OFFICE OF THE PRINCIPLE CHIEF CONSERVATOR OF FOREST, HOFF, RAJASTHAN, JAIPUR

CCF resubmitted the proposal after amendment corrections. User Agency submits digital maps of the proposal FP/RJ/Road/7127/2014 as per required by MOEF & CC for their letter no.8B/Raj/06/24/2015/FC/04 dated 1.04.2015. Land suitability certificate, CA scheme, Details of NPV, FRA certificate are enclosed and after examination of digital maps some query in the submitted digital maps.

Sheet 1

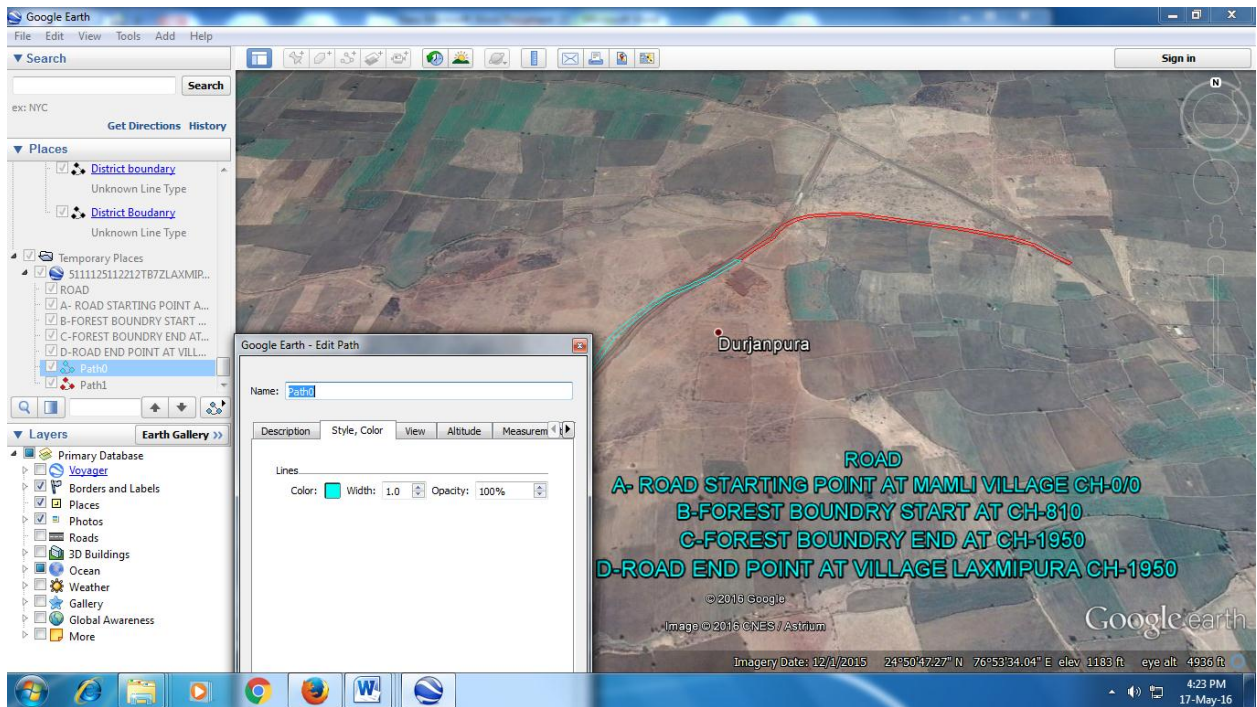
1. Digital Maps are in polyline shape while MOEF &CC required digital maps in polygon shape for DSS analysis.
2. Sheet No 1 expressed that provided digital maps are prepared in path. Total path are 2.
3. Sheet no 2 expressed that provided digital maps are in line shape.
4. Sheet No 3 expressed that provided digital maps have a length of 2302 meter in forest while the length of road in forest is only 1140 meter.

Hence, Digital maps are not satisfactory, the proposal is to be forwarded to CCF for modify/ revised digital maps.
